# **FOREST MEADOWS SUBDIVISION**

**SUBDIVISION APPLICATION SB#03-21 CUP#03-21**

## **STAFF REPORT**

**PLANS UNDER REVIEW:** “Forest Meadows” Map 237 – Lot 032 Hudson, New Hampshire; prepared by Meisner Brem Corporation, 142 Littleton Road, Westford, MA 01886; prepared for KLN Construction Company, Inc., 70 Bridge Street, Unit 1, Pelham, NH 03076; consisting of 16 sheets, with General Notes 1-12 on Sheet 2; dated April 5, 2021, last revised June 7, 2021.

NH GR-2A GUARD RAIL DETAIL  
 NOT TO SCALE

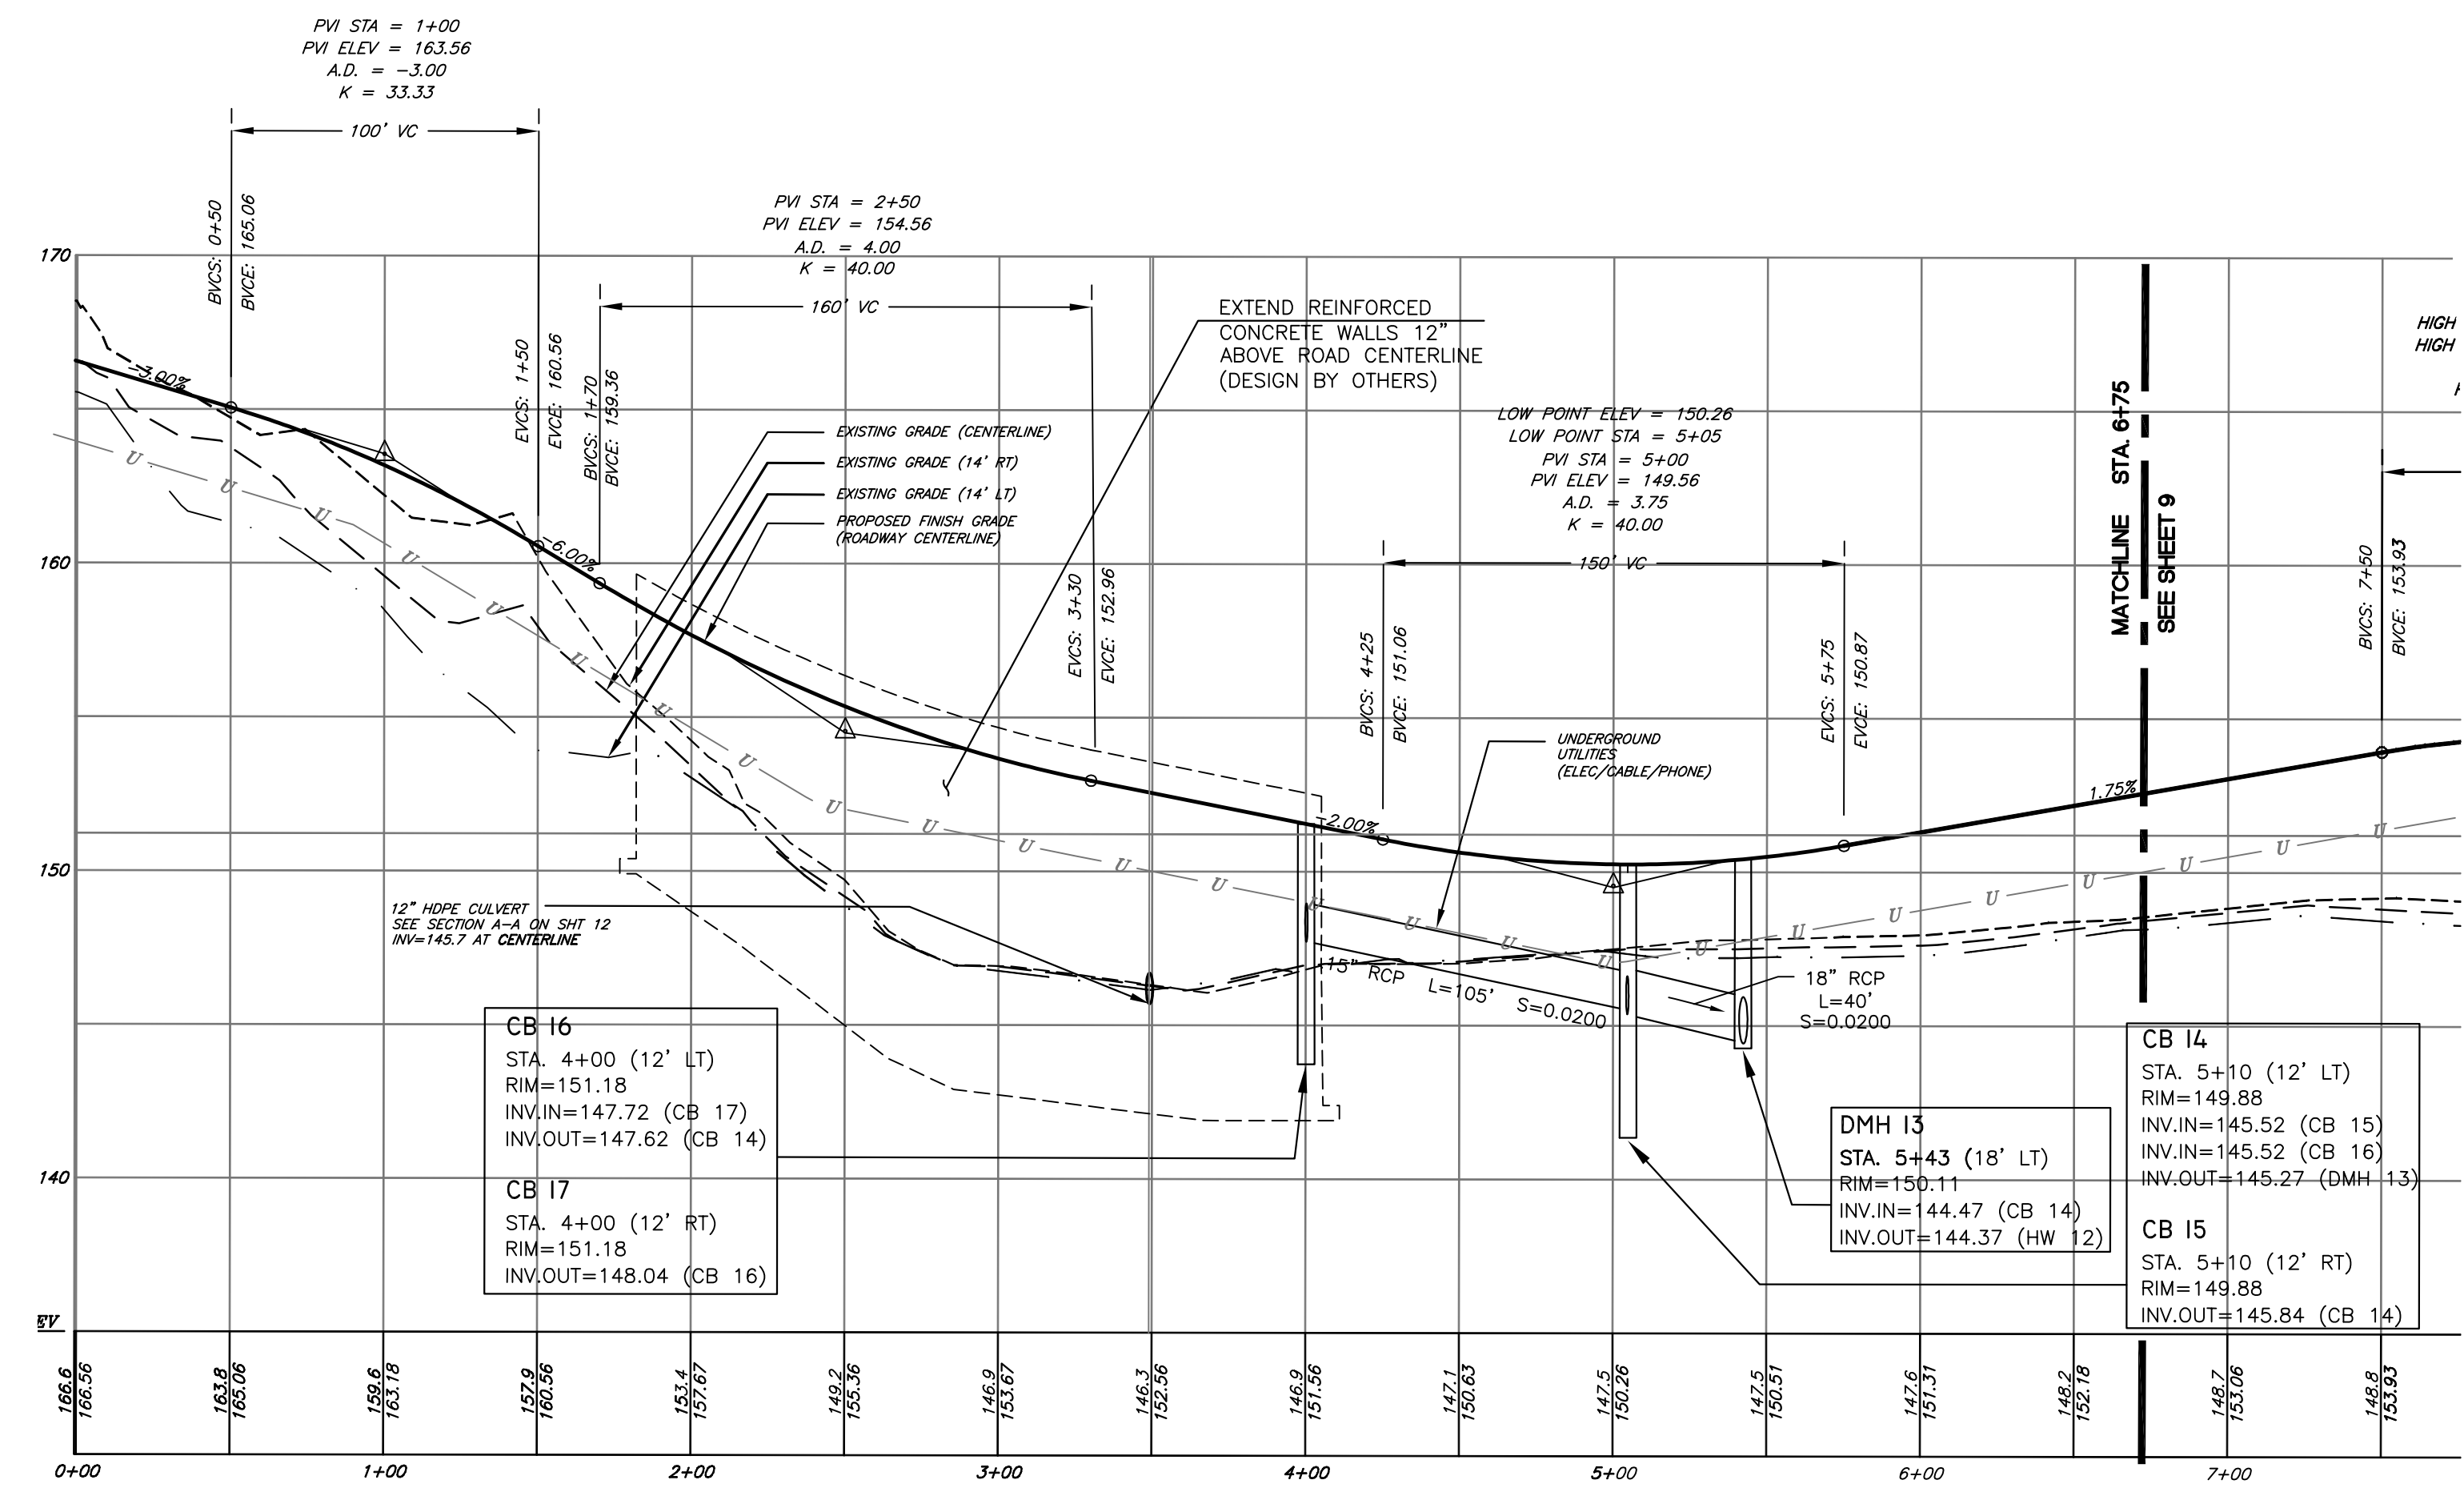
Item 7. A retaining wall is not a guard rail. Please revise your plans to provide guard rail on both sides and hand rail for the sidewalk portion

- d. *Former Fuss & O'Neill Comment: HR 289-18.D. The applicant has requested a waiver for the steep slopes within the Right-of-Way from stations 0+00 to 4+00 due to the narrow property. We note that the applicant should review the need for guardrail within this area of steep slopes adjacent to the road. / The applicant has stated that they feel the concrete retaining wall by the culvert will act as a guardrail for vehicles. We understand that further revisions to the retaining wall design are being evaluated and discussed with the Town Engineer, including the lowering of the retaining wall and the addition of guardrail.*

**Current Fuss & O'Neill Comment:** The applicant added guardrail and a detail to the plan set. The applicant should also provide details for the guardrail end section on the plan set. Also, the applicant should coordinate the south side guard rail with underground utilities to ensure that there are no conflicts during installation.

3d. Guard rails are added on both sides of the roadway at the request of the Town Engineer. See detail on sheet 8.

3j. Guard rails added per comment 3d, above. Pedestrian protection is now provided by the guard rail situated between the roadway and sidewalk.

7. Guard rail added on both sides, and pedestrian rail added on sidewalk side. Grass strip is added between roadway and sidewalk at the crossing in order to fit guard rail.

Current Fuss & O'Neill Comment: The applicant has added a guardrail between the roadway and the sidewalk. No Further Fuss & O'Neill comment.

**GRADING PLAN**  
**'Forest Meadows'**  
58R GOWING ROAD  
HUDSON, NEW HAMPSHIRE  
ASSESSOR'S MAP 237 / LOT 032  
OWNER/APPLICANT  
KLN CONSTRUCTION COMPANY, INC.  
70 BRIDGE STREET, UNIT 1  
PELHAM, NH 03076  
BK 9353 PG 2517, HCRD

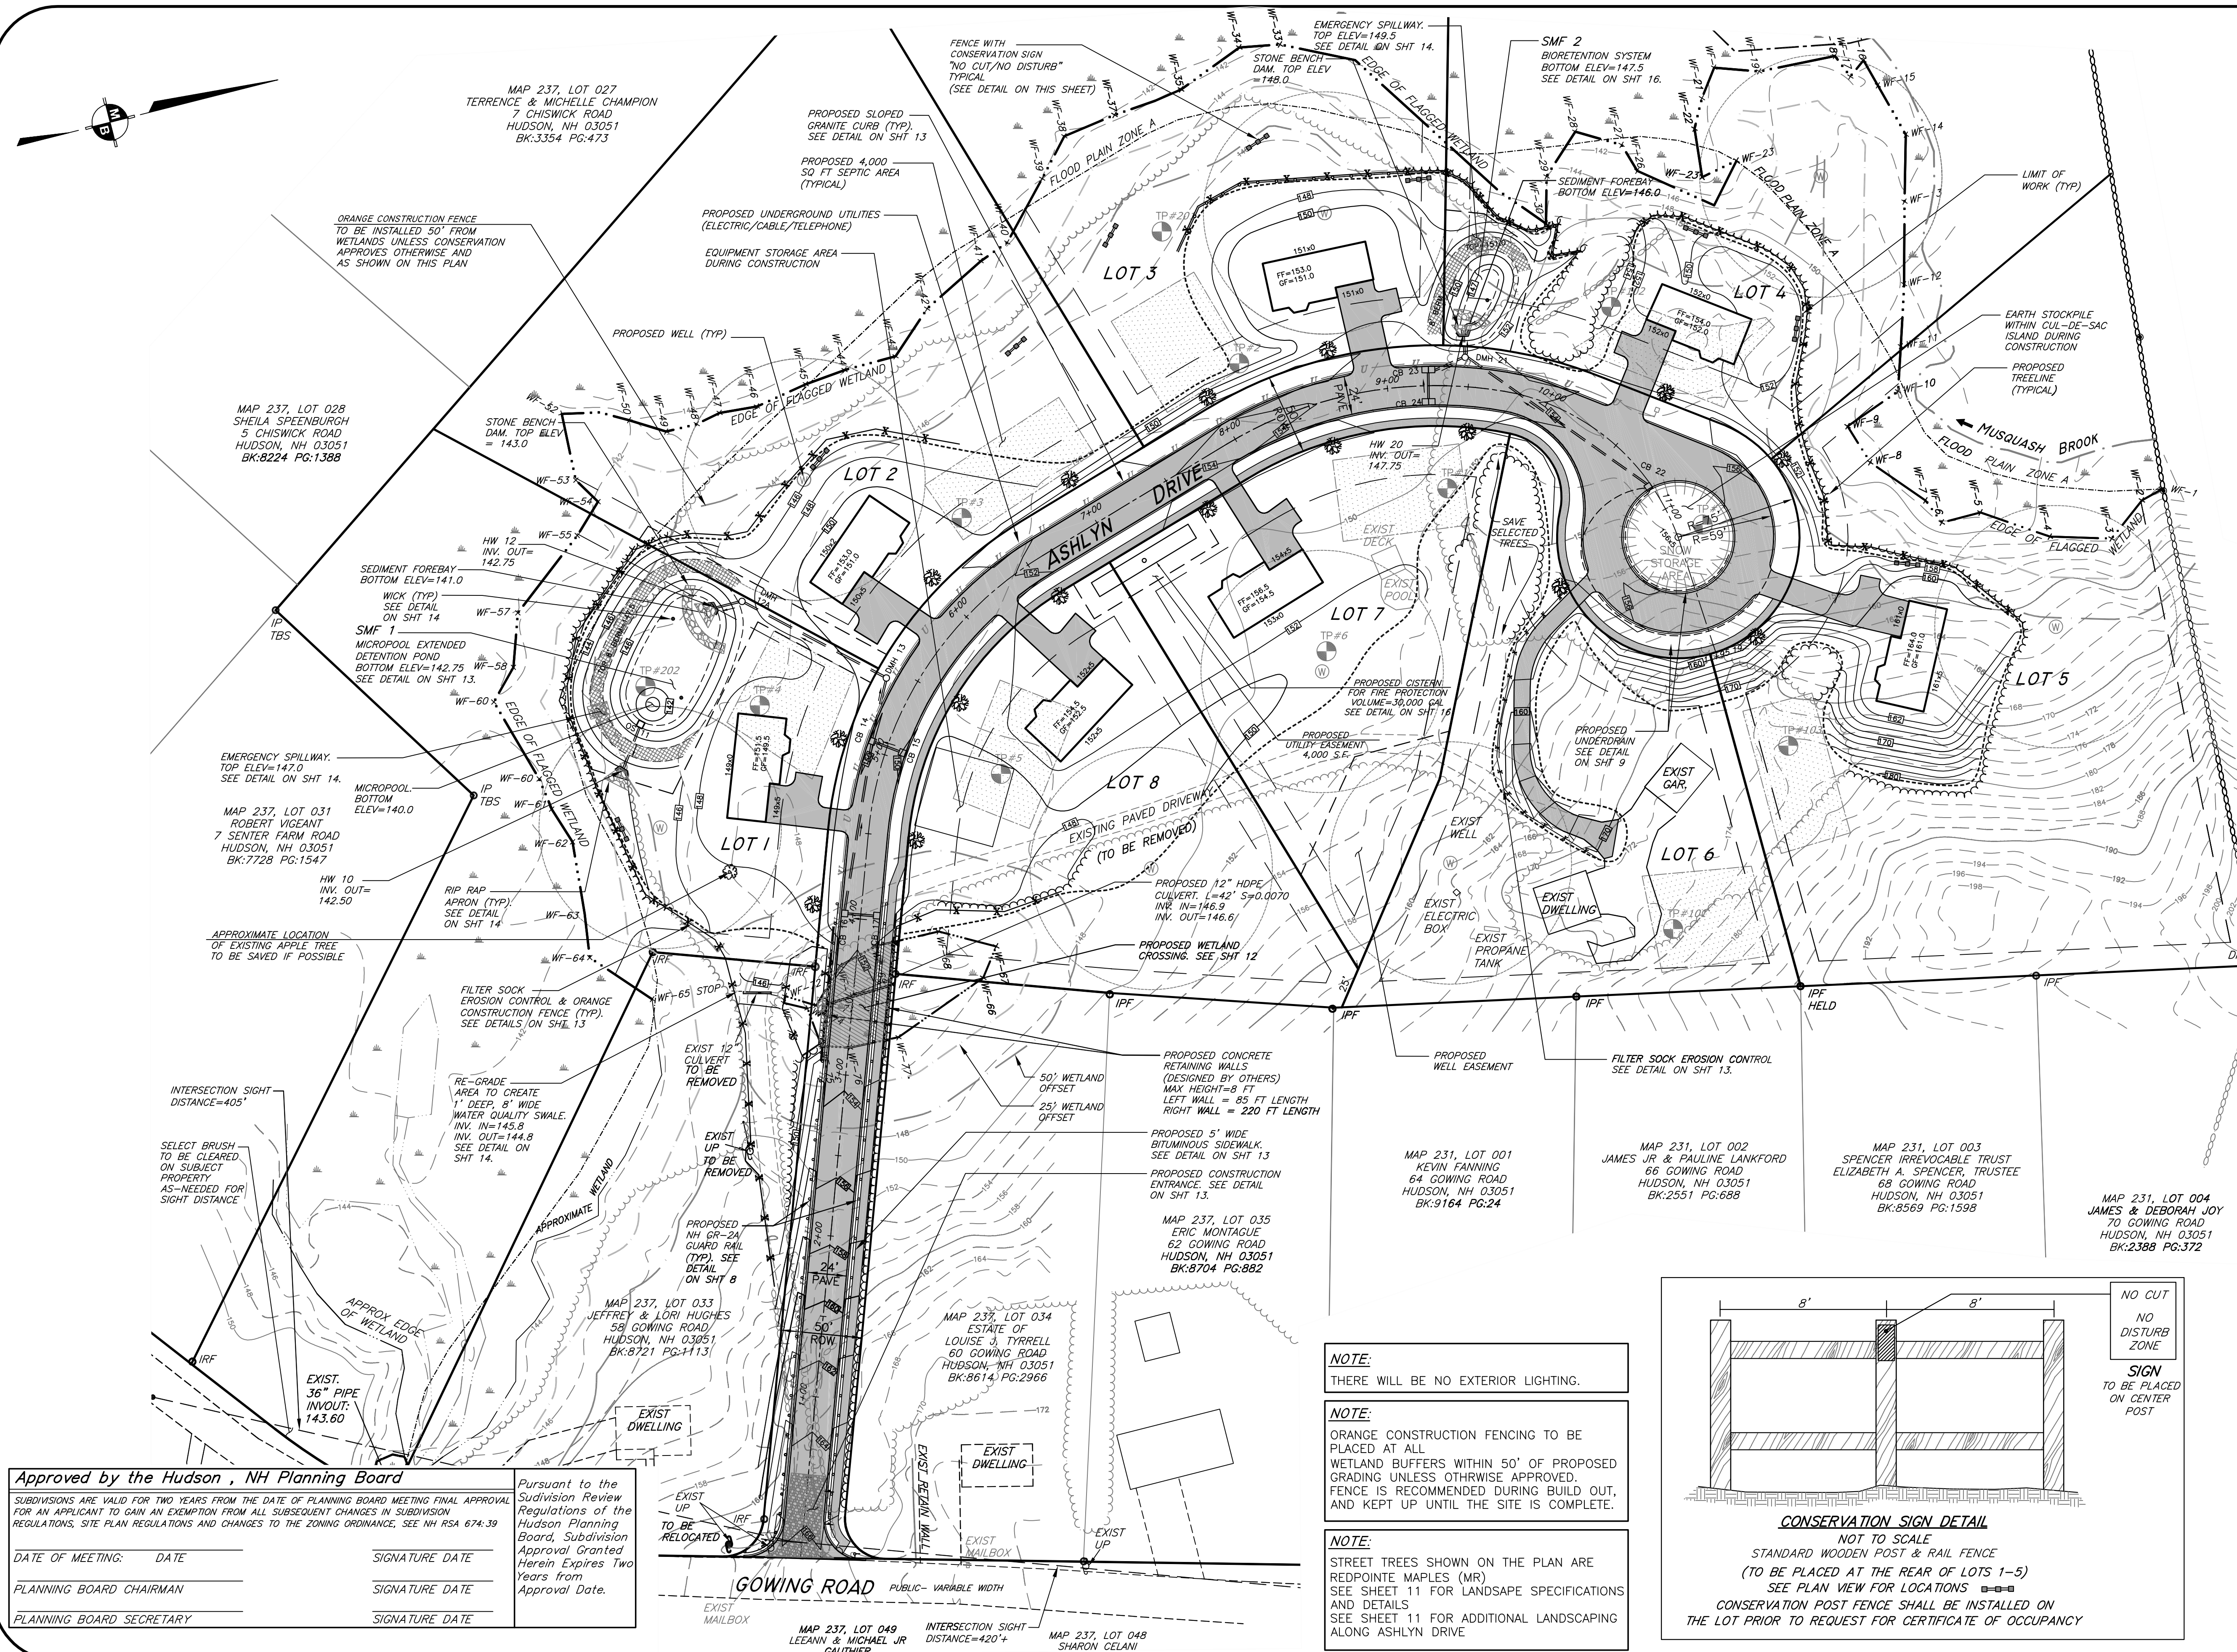
16. The applicant shall install “No Cut/No Disturb” signs at 150 foot intervals along the outside edge of the 50 foot wetland buffer areas of proposed lots 1 through 5 and update the plan set sheet 10 of 16 (Grading Plan) to show these locations. Such signs shall be installed prior issuance of certificate of occupancy for lots 1 through 5.

Item 17. This approach is acceptable to Engineering Departments if a stipulation is added to state that all drainage and its components, outside of dedicated right of way shall remain responsibility of the association.

7. Stockpile location shown within cul-de-sac. Equipment storage location shown on Lot 8. See Sheet 10.

17. Note added to grading plan which states drainage outside ROW to be maintained by the HOA.

**SMF 1 DETAIL - MICROPOOL EXTENDED DETENTION POND**  
NOT TO SCALE

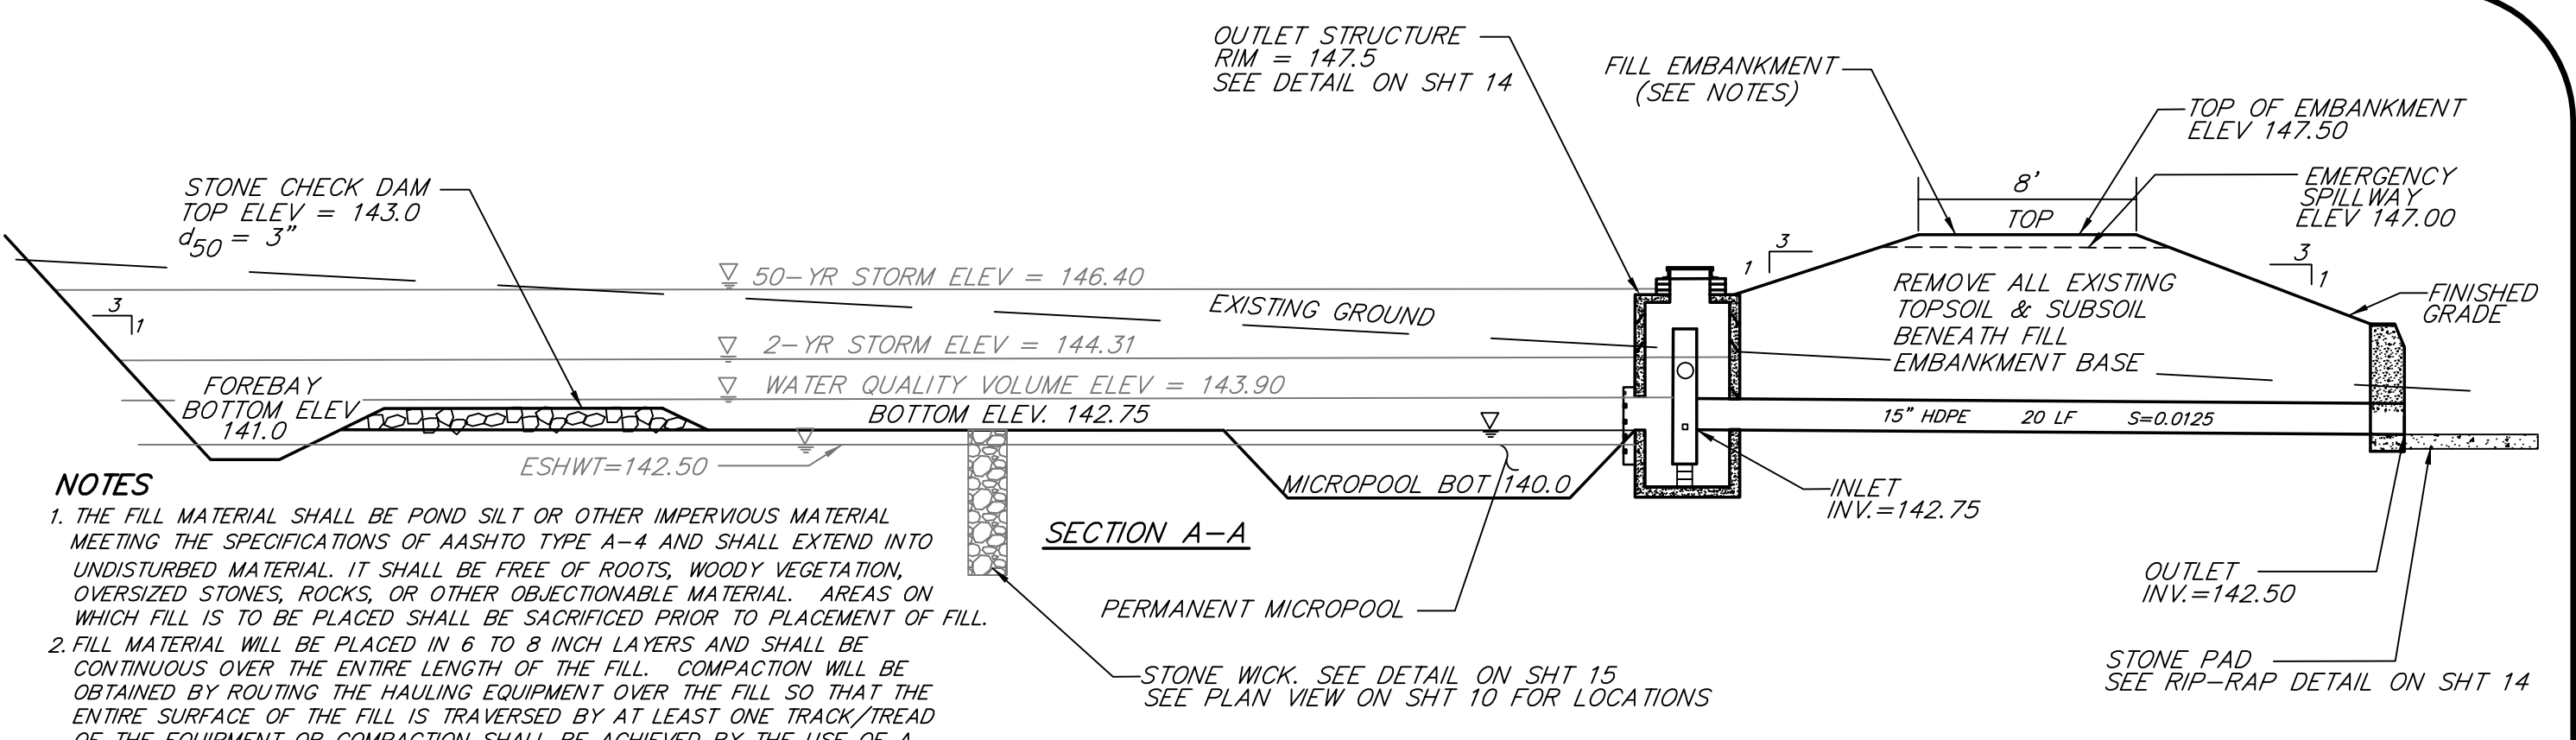
- d. *Former Fuss & O'Neill Comment: HR 290-7.A.6. The applicant should provide information as to how the stormwater system is designed to account for frozen ground conditions. / The applicant has noted the addition of a note on the plan view, and a stone wick detail. The applicant should add the installation of the proposed stone wick directly to the SMF 1 & 2 details on Sheets 13 and 16.*

**Current Fuss & O'Neill Comment:** The applicant has added a stone wick to the SMF 1 detail on Sheet 13, along with a reference to a wick detail on Sheet 15 which appears to be incorrect. The applicant should add the wick detail to the appropriate sheet and update the sheet reference on Sheet 13.

17. We have stone wicks shown for frozen conditions, on sheet 14 – basically gravel cylinders that extend below the frost layer Where is 2" perforated pipe the design guidelines? I don't see it in there.
